Transmittal #: 11
Date: 4/17/2015
Job: M117 VTRANS CASTLETON BRF 015-2(10)

Job: M117
VTRANS CASTLETON BRF 015-2(10)
Castleton BRF 015-2
Route 30
Castleton, VT

Submittal Title: Next Beams

DATE:	4.17.15	**JOB #**	23456-015
ATTN:	Kevin Ture/Mike Garn		
RE:	Castleton Bridge/BRF015-2(10)

LIFTING LOOP/LIFT INSERT DESIGN CALCULATIONS

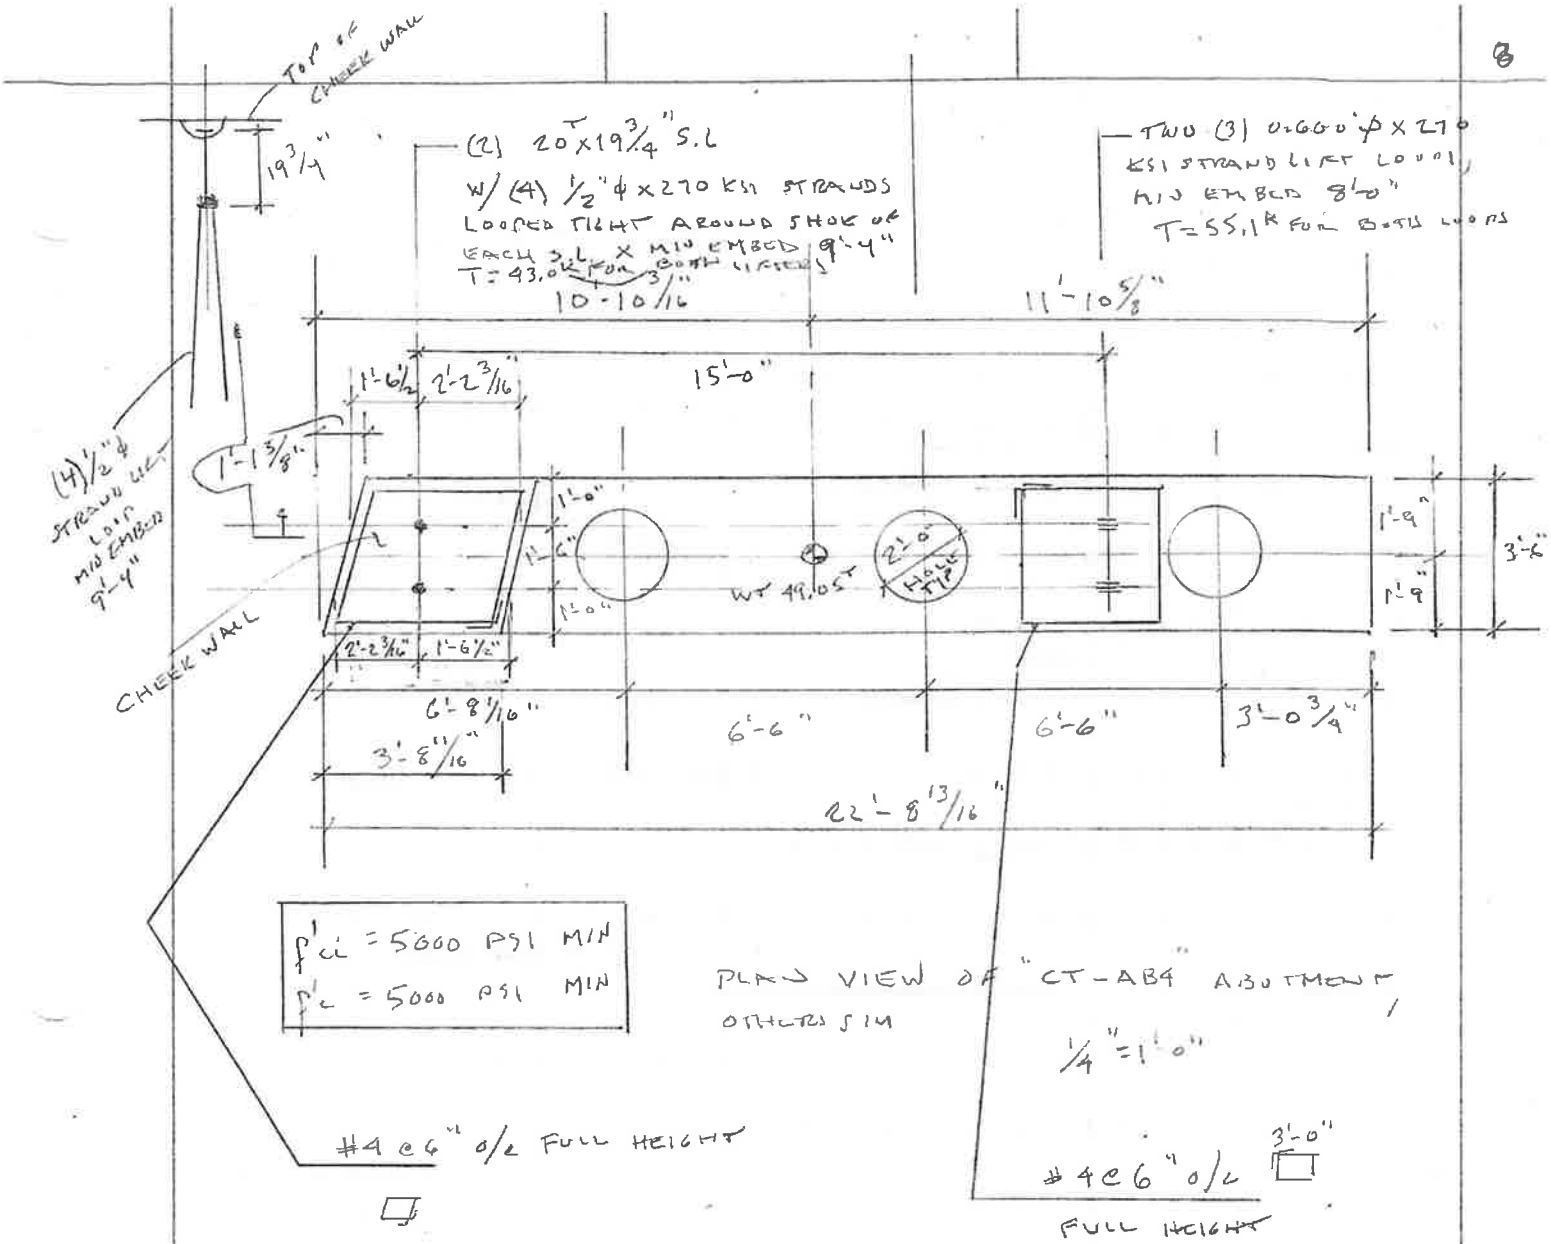
△1 THESE CALCULATIONS REVISE THE LIFT LOOPS FOR THE ABUTMENTS ONLY. THE STRAND LIFTERS IN THE CHEEK WALL WILL BE REPLACED W/ (2) 20T S.L. ANCHORS WITH (9) 1/2" ϕ STRANDS LOOPED AROUND THE SHOE OF EACH LIFTER FOR ADDITIONAL ANCHORAGE. THE (5) 0.600" ϕ STRAND LIFT LOOP AT THE OTHER END OF THE ABUTMENT WILL BE REPLACED W/ TWO (3) 0.600" ϕ STRAND LIFT LOOPS. THE LOCATION OF THE LIFT LOOPS/LIFT INSERTS IS APPROX UNCHANGED RELATIVE TO THE C.G. OF THE ABUTMENT & ∴ THE LOADS AT THE LIFT LOOPS/LIFT INSERTS FROM THE PREVIOUS CALCULATIONS MAY BE USED. CALCULATIONS ARE DONE FOR "CT-AB4", THE HEAVIEST ABUTMENT, BUT ARE APPLICABLE FOR ALL THE ABUTMENTS, UNO. SEE SKETCH.

1. TOP OF STRAND LIFT LOOPS & INSERTS TO BE SUCH THAT A LEVEL PICK CAN BE MADE.

2. ADD TIES AS SHOWN.

STRAND LIFTER PLAN VIEW FOR CT-AB4

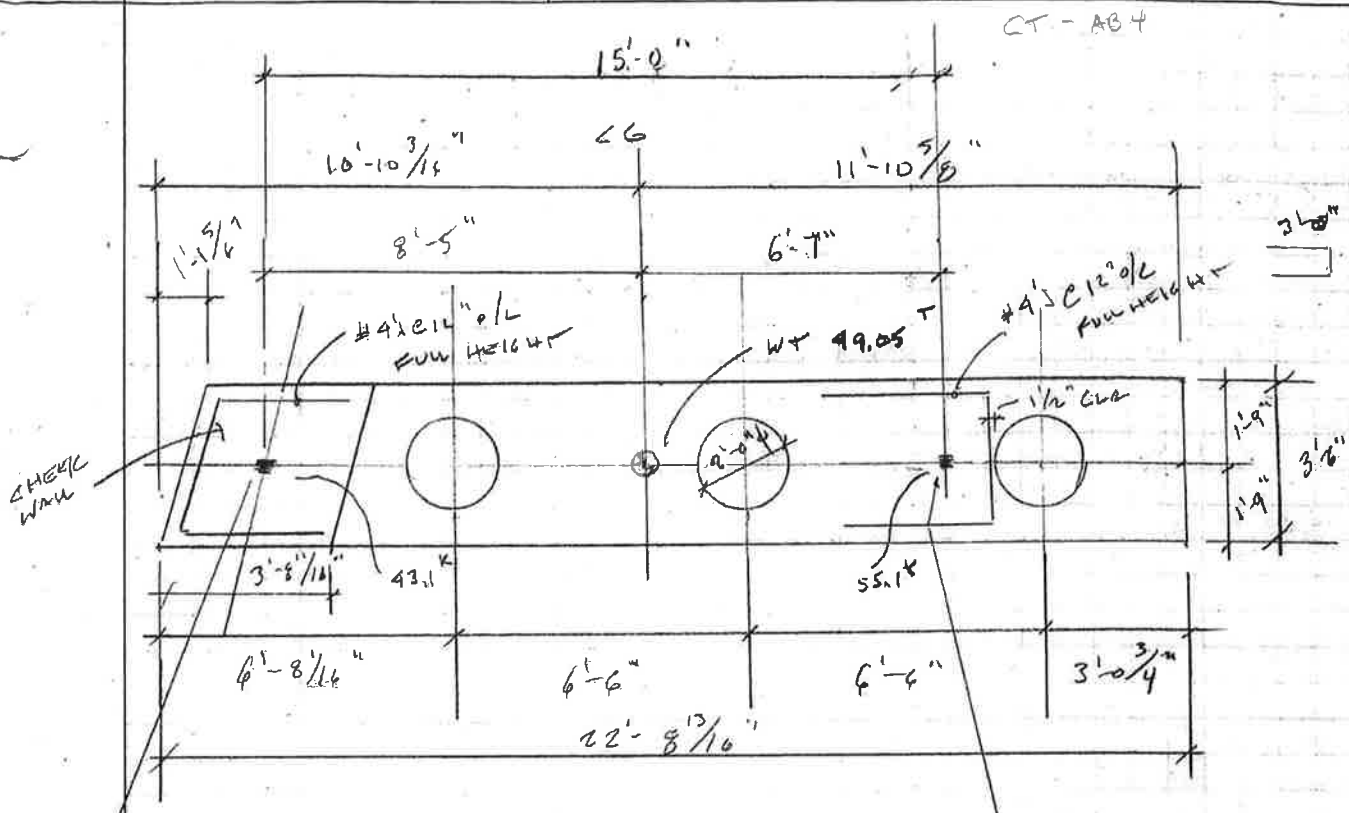
TENSION LOAD @ CHECK WALL LIFTER $= \frac{49.05 \times 6.58 \times 2}{15.0} = 43.0^{k}$

TENSION LOAD @ OTHER LIFTER $= 49.05 \times 2 - 43.0 = 55.1^{k}$

NOTE: 1.) TOP OF TWO LIFT LOOPS TO BE LEVEL.

2.) SPLAY BOTTOM OF LIFT LOOP STRANDS AS MUCH AS PRACTICAL TO ENGAGE AS MUCH CONCRETE AS POSSIBLE.

3.) ADD #4 HAIRPIN AS SHOWN
